ADDENDUM NO. 4
Request for Tender No. 24-01-00517

Milton Town Hall & Fire Station No. 2
HVAC Equipment Replacement

ADDENDUM No. 4

PROJECT:	H.V.A.C. Replacement at Town Hall & Fire Station #2	DATE:	23 Oct. 2024
PROJECT #:	24034	FROM:	Binayak Raj Maurya
TO:	Town of Milton	ATTENTION:	Daniele Santos

DRAWN BY: VA SCALE: AS NOTED

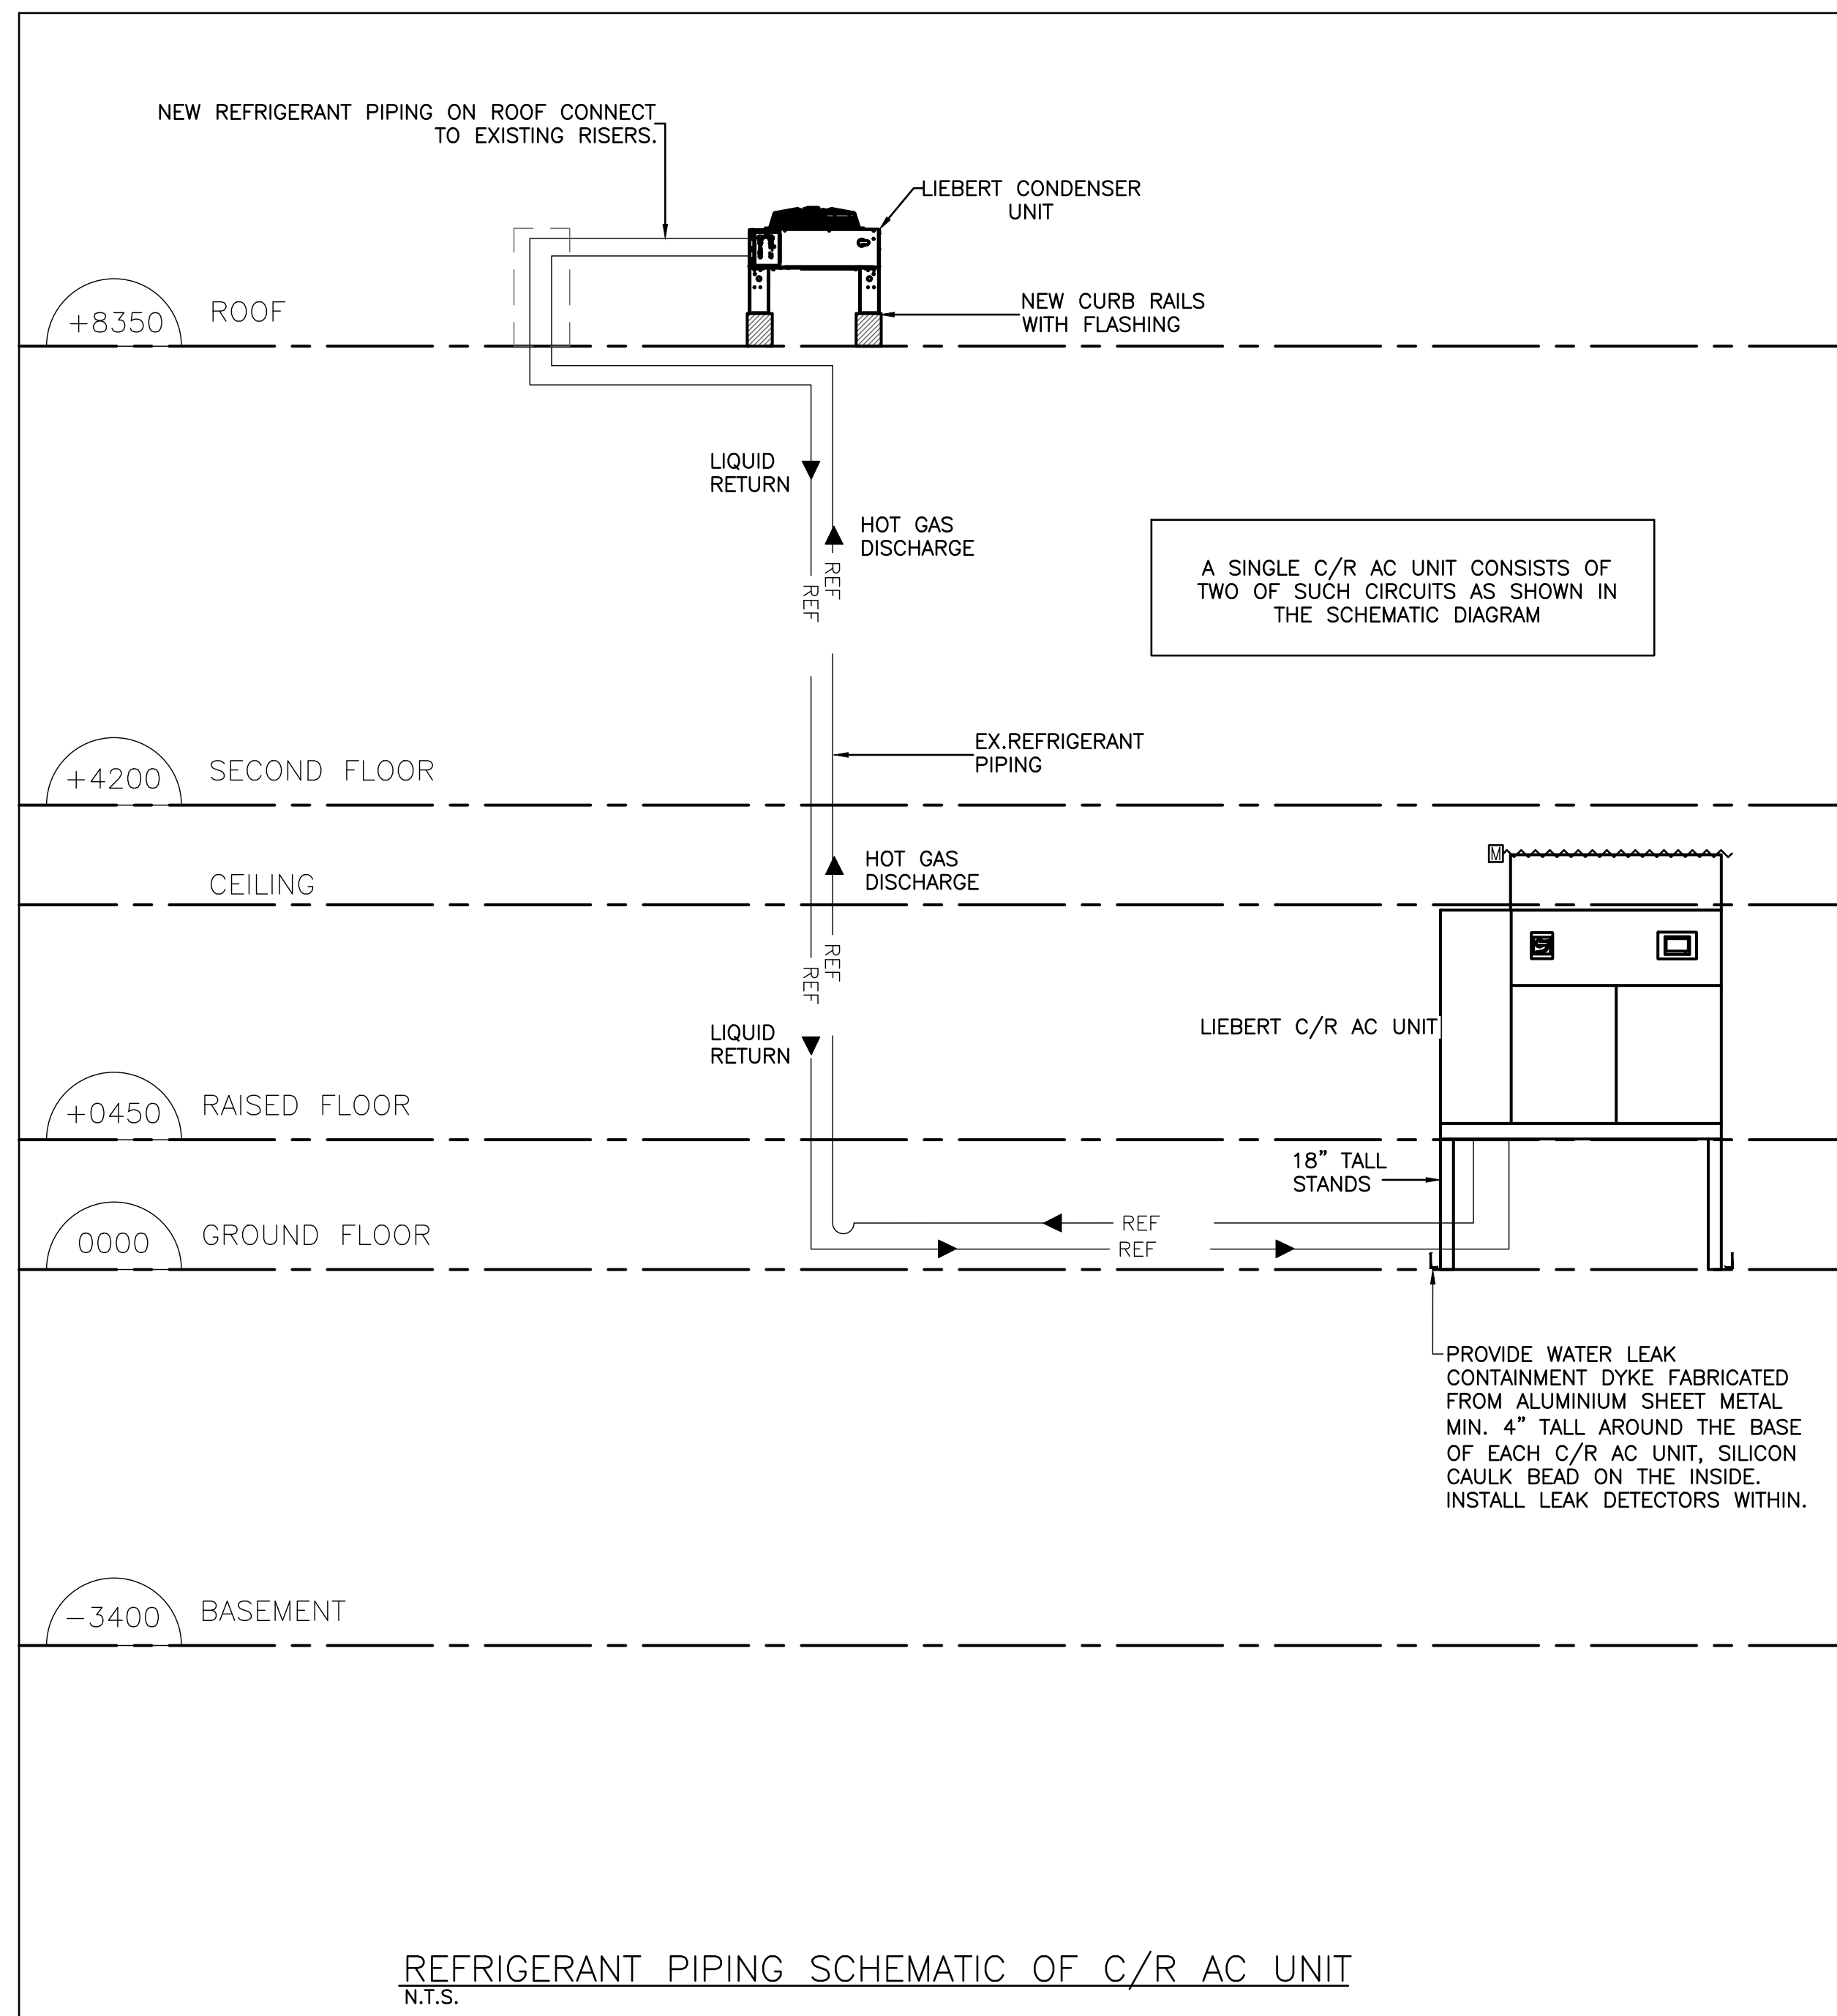
1.2 Refer to Mechanical Drawing M0.4 Rev. C

- Revised airflow rate for C/R AC-1,2.

C/R AC UNIT SCHEDULE - TOWN HALL																								
INDOOR UNIT													OUTDOOR UNIT											
INDOOR UNIT TAG	INDOOR UNIT MAKE AND MODEL No.	OUTDOOR UNIT TAG	OUTDOOR UNIT MAKE AND MODEL No.	OPERATING RANGE DB (°F)	REFRIGERANT	UNIT LOCATION	MOUNTING TYPE	MAX AIRFLOW (CFM)	ESP (IN. WC)	NET COOLING CAPACITY (kW)	SENSIBLE COOLING CAPACITY (kW)	ELECTRICAL			WEIGHT (LBS)	UNIT LOCATION	MOUNTING TYPE	COOLING CAPACITY (Btu/hr)	ELECTRICAL			WEIGHT (LBS)	SOUND (dBa)	REMARKS
												V/PH/HZ	FLA	BREAKER SIZE					V/PH/HZ	FLA	BREAKER SIZE			
C/R AC-1.2	LIEBERT DS070A	CU-1,2	LIEBERT MCM080E	50 TO 104	R407C	I.T. DATA CENTRE	FLOOR MOUNT ON 18" STANDS LEVEL WITH RAISED FLOOR	9,600	0.2	74.1	73.2	575/3/60	46.4	60	1970	ROOF	18" LEGS	N/A	575/3/60	2.4	15	906	N/A	SEE NOTES BELOW

DRAWING No.:  
**M 0.5**

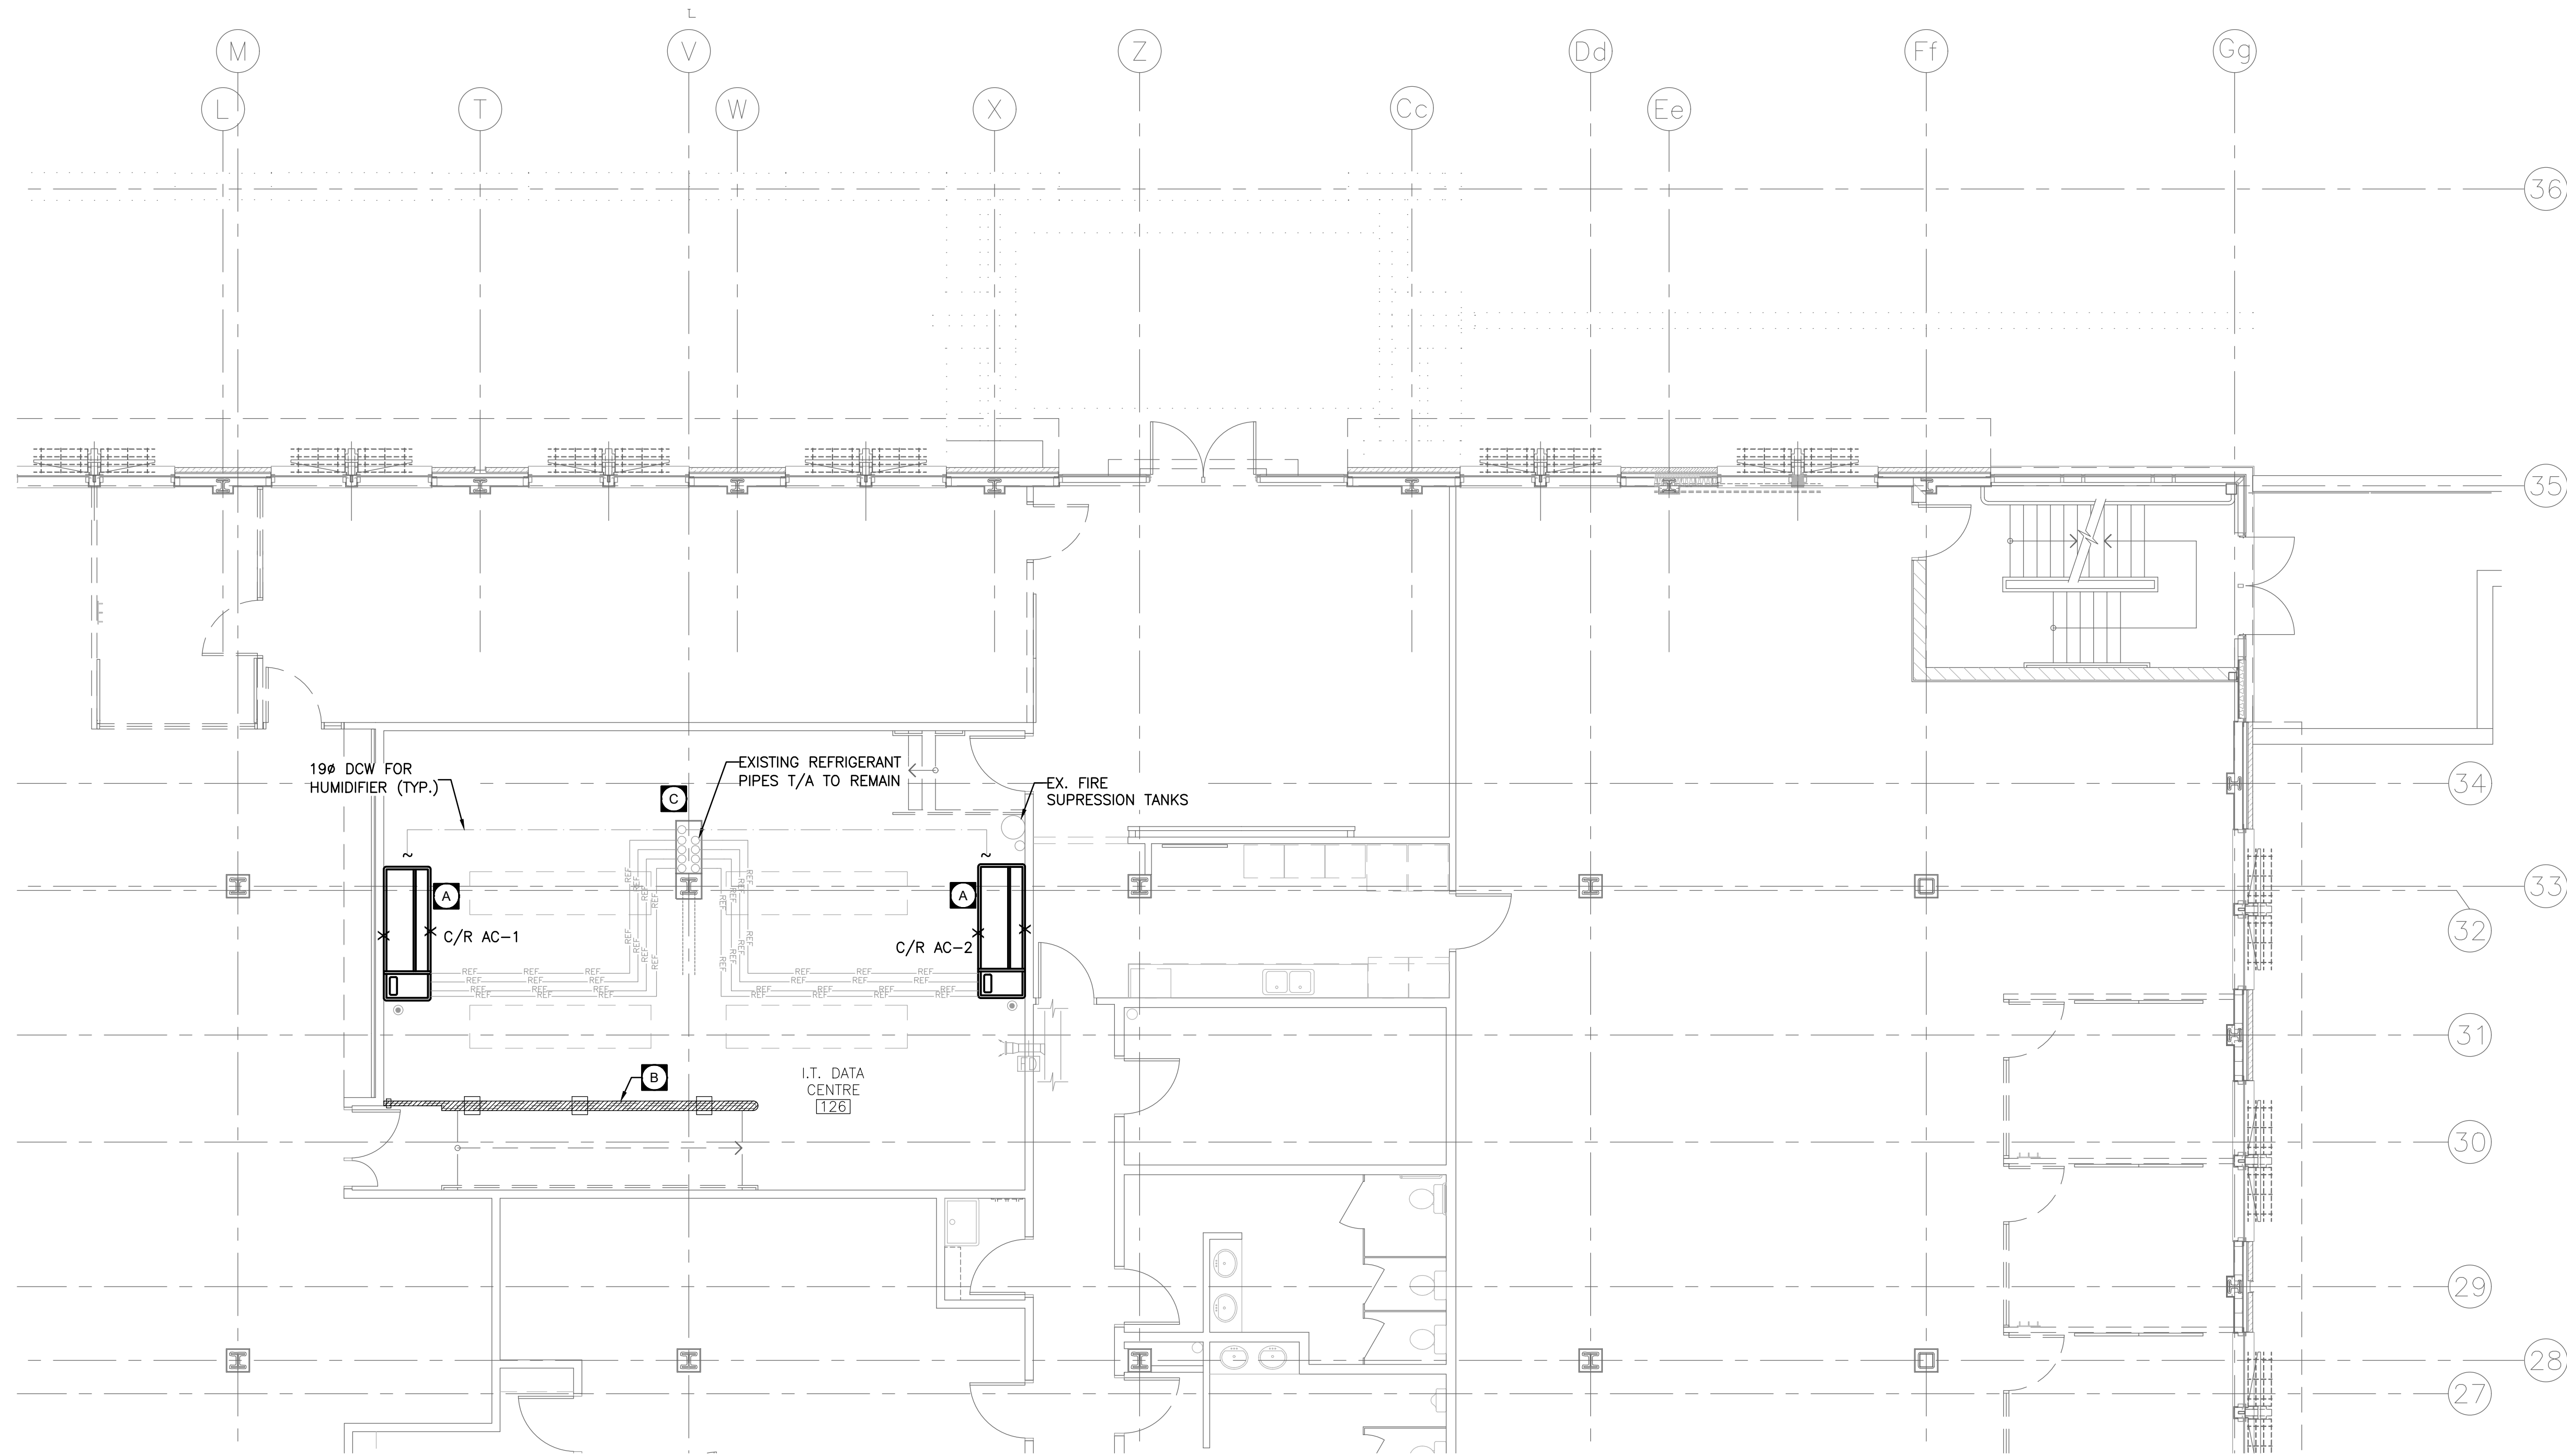
Addendum 3, Question 7:

Can you provide details on the new supports for the 20ton units on the roof?

1.3 Refer to Mechanical Drawing M0.5 Rev. C

- Revised roof curb detail.

REVISED ANSWER:

Refer to “Mechanical Drawing M0.5 Rev. C - Revised roof curb detail”.
